Our ref: 100311-02

Re: Baldon Wind Farm – Wind Turbine Obstacle Lighting

This correspondence responds to a request for an Aviation Obstacle Lighting Plan in accordance with the relevant guidelines and as per CASA's advice on the EIS.

Figure 1 Proposed obstacle lighting layout

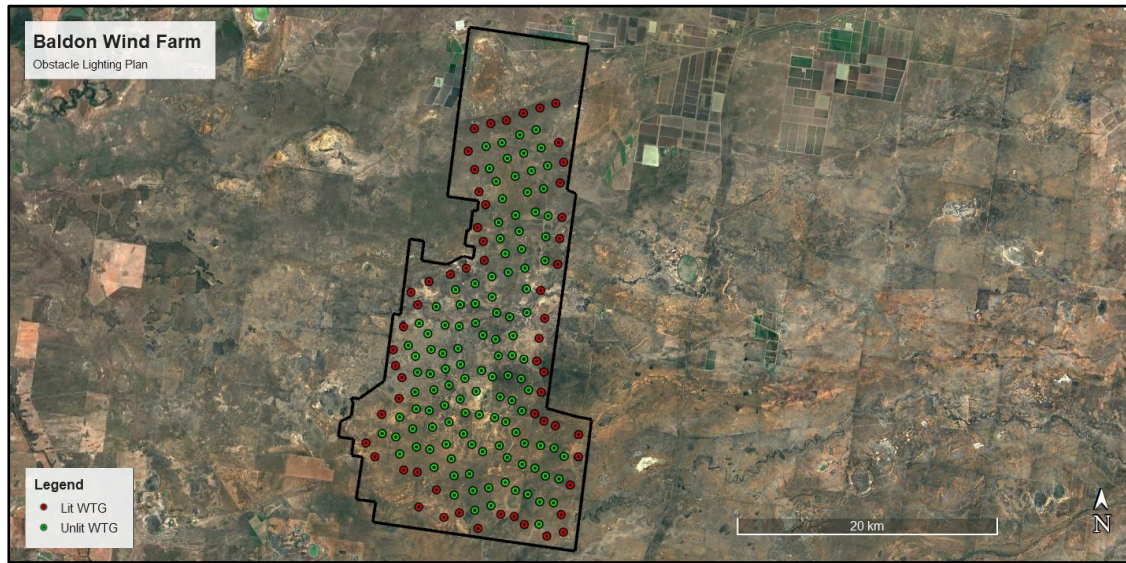
CASA responded on 13 August 2024, and required obstacle lighting for the Baldon Wind Farm:

Contrary to Recommendation 9, CASA considers the proposed wind farm will be a hazard to aviation safety and recommends that the wind farm is obstacle lit with steady medium-low intensity red obstacle lighting in accordance with the National Airports Safeguarding Framework Guideline D 'Managing the Risk of Wind Turbine Farms as Physical Obstacles to Air Navigation' National Airports

International standards require 2,000 candela lighting intensity on the nacelle (also recommended in the NASF guideline) and 200 candelas at the mid-point of the turbine mast. CASA recommends that 200 candela as a minimum intensity lighting on the nacelle would suffice (due mainly to the lack of background lighting in the vicinity of the turbines). The obstacle lighting should be monitored to alert the wind farm operator of any outage. The lighting system design should ensure that some of the obstacle lights remain on during an outage. CASA is prepared to review a lighting plan that indicates which turbines are proposed to be lit.

In applying the requirements of CASR Part 139 MOS or NASF Guideline D in relation to obstacle lighting on wind turbines, and in particular the 900 m interval, it is suggested that the following wind turbines (red dots illustrated in Figure 1 and Table 1) are lit. The Baldon Wind Farm should have 200 cd low intensity steady red obstacle lighting that is fitted and operational.

- *Lights:*
 - 2 low intensity steady red lights (per lit wind turbine):
 - Fixed lights showing red
 - A horizontal beam spread that results in 360° coverage around the obstacle

- A minimum intensity of 200 candela (cd)
 - A vertical beam spread (to 50% of peak intensity) of 10°
 - A vertical distribution with 50 cd minimum at $+6^\circ$ and $+10^\circ$ above the horizontal

- Not less than 10 cd at all elevation angles between -3° and $+90^\circ$ above the horizontal.
 - Obstacle lights should operate at night, and at times of reduced visibility.

- *Shielding:*
 - Shielding of the downward component of obstacle lighting is permitted, and if used, must be such that:
 - No more than 5% of the nominal light intensity is emitted at or below 5° below the horizontal

- No light is emitted at or below 10° below horizontal
 - Two lights must be provided on top of the generator housing in a way that allows at least one of the lights to be seen from every angle in azimuth.
